Informal document GRSG-101-10-Rev.1

(101st GRSG 2011, agenda item 6)

Draft Corrigendum to Regulation No. 58, 02 series of amendments (Rear underrun protection)

Explanatory Diagrams:

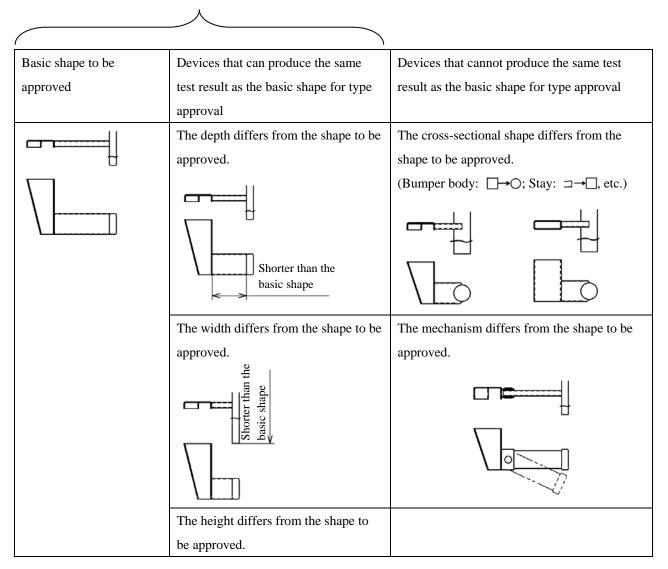
Paragraph 4.1.2., correct to read:

"4.1.2. "Type of RUPD" means RUPDs which do not differ with respect to the essential characteristics such as shape, dimensions, attachment, materials and the markings cited in paragraph 5.2.2 below.

At the contracting party's consent, if the deformation levels are to be equal to or lower than the type approved device, new devices may be applied by manufacturer as the same type."

It seems to us that other type approvals are needed under current paragraph 4.1.2., even if differences of shape, dimensions, attachment materials and markings are very small. In case of slight differences, Japan would like to regard them as the same type for reduction of applicant's work load,

For the devices which have been type approved, if the deformation levels are to be equal to or lower than the type approved device, new devices may be applied by manufacturer as same type.
